Request for Additional Information No. 610, Question 10.04.08-9

U.S. EPR Standard Design Certification

SRP Section: 10.04.08 - Steam Generator Blowdown System

Question 10.04.08-9:

Figure 2.8.7-1—Steam Generator Blowdown System Functional Arrangement

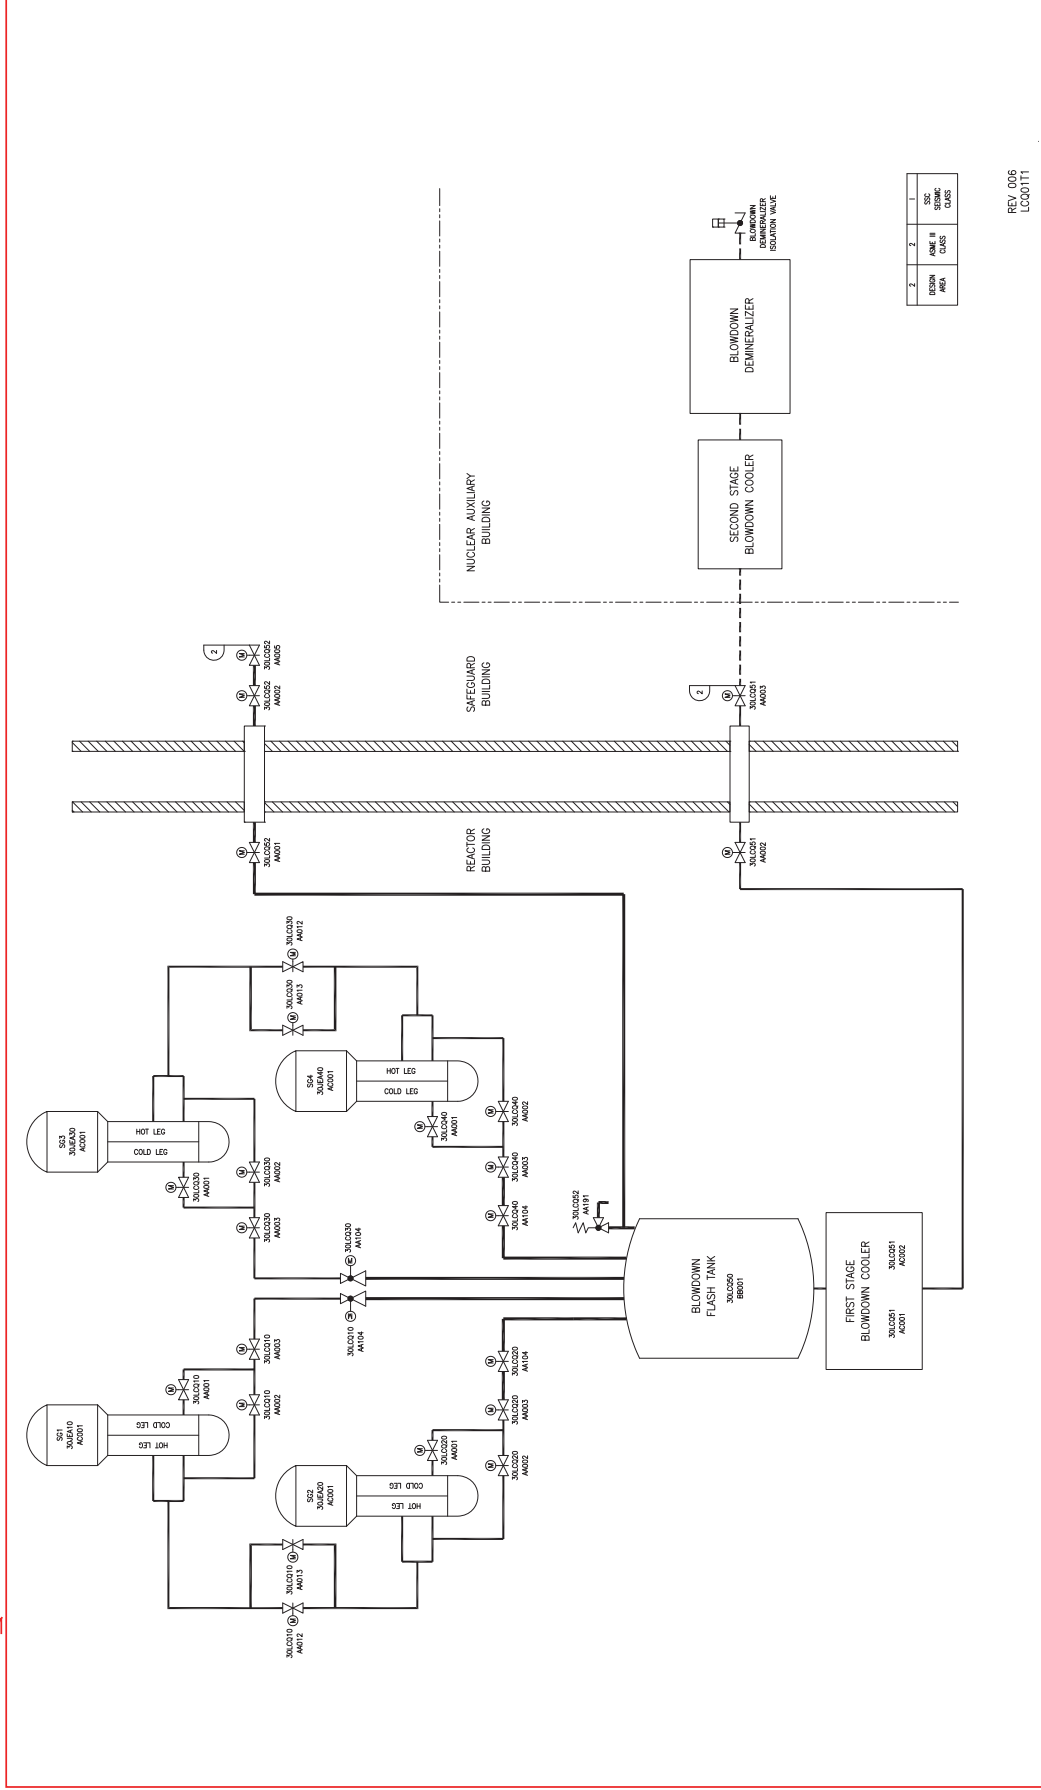
U.S. EPR FSAR Tier 1, Figure 2.8.7-1—Steam Generator Blowdown System Functional Arrangement and U.S. EPR FSAR Tier 2, Section 10.4.8.3.2 will be revised and U.S. EPR FSAR Tier 1, Section 2.8.7, ITAAC Item 4.5 will be added to clarify that the blowdown demineralizer isolation valve (30GDA10AA013) closes upon receipt of a high temperature signal downstream of the demineralizer. U.S. EPR FSAR Tier 2, Section 10.4.8.3.2 states that this valve is automatically closed if the temperature of the blowdown water downstream of the second stage blowdown cooler reaches 131°F. The flash tank is then prevented from draining to the condenser, causing an increase in flash tank water level. The blowdown operation is stopped by the automatic closure of the SG blowdown adjusting valves or SG blowdown isolation valves on high water level.

4.5 The blowdown demineralizer isolation valve closes upon receipt of a high temperature signal downstream of the demineralizer.
